Zoning Board of Appeals June 12, 2024 6:00 pm 1 Auburn Way

1-ZBA 24-001, application made by Sullins Engineering, LLC to request a variance from Section 17.91.050(2)(b)(i), to reduce the percentage of widows required on the street-facing building facade between three feet and eight feet in height for the purpose of constructing six (6) town-homes, on a portion of 0 6th Street (Tax Parcel AU11 121 pt.).

PLANS FOR ADMINISTRATIVE REVIEW "AUBURN DOWNTOWN OVERLAY DISTRICT"

CITY OF AUBURN STAFF REPORT ZONING BOARD OF APPEALS

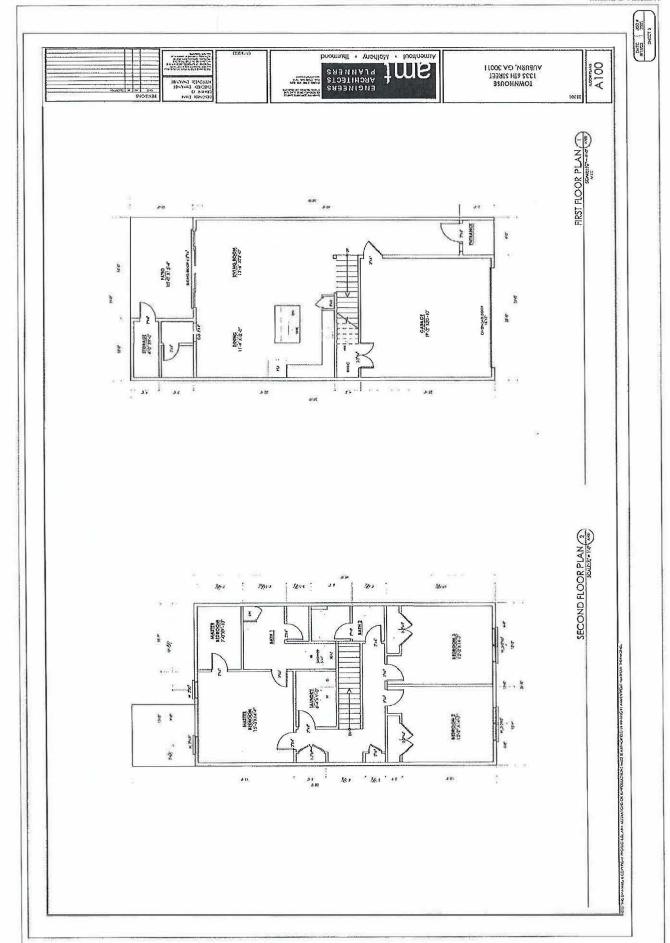
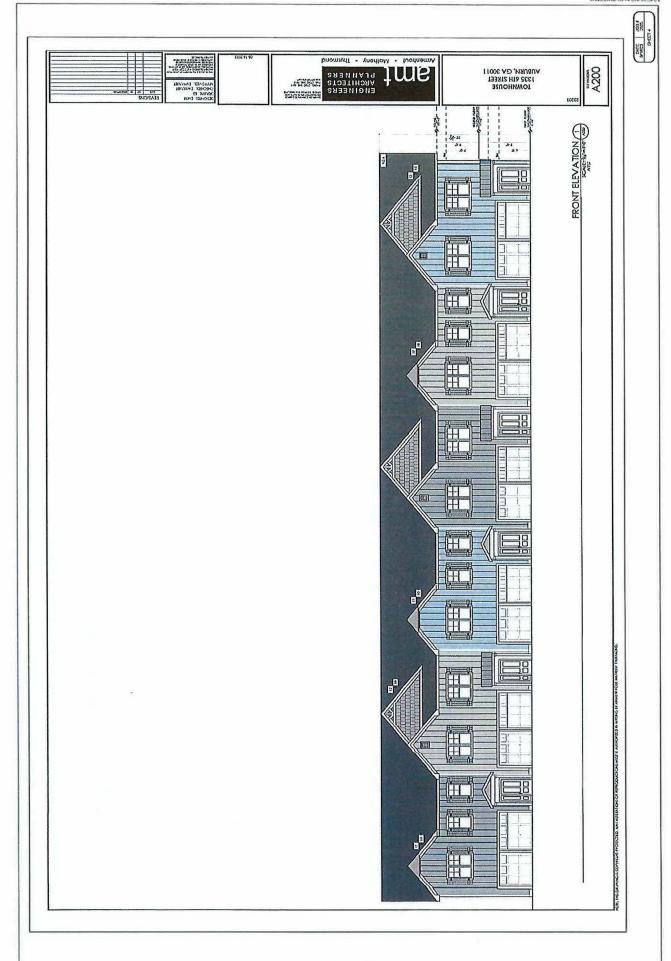
The site plan has been reviewed for compliance with the requirements of the Auburn Downtown Overlay District (17.91) and staff has identified the following deficiencies:

- Facade Design [17.91.050(2)]:
 - o Front, side, and rear façade style shall be in accordance with one of the following architectural styles: Victorian, Arts and Crafts (Craftsman), or Art Deco. These styles contribute to the historic nature of the downtown area. [17.91.050(2)(a)]
 - The submitted architectural renderings are not in accordance with the above referenced styles. See supplemental memo from CPL in relation to the architectural renderings submitted as part of this request [Note: this memo is forthcoming].
 - A minimum of seventy-five percent of the street-facing building façade between three feet and eight feet in height must be comprised of clear windows that allow views of indoor space or product display areas. [17.91.050(2)(b)(i)]
 - The submitted architectural renderings do not appear to meet this requirement.
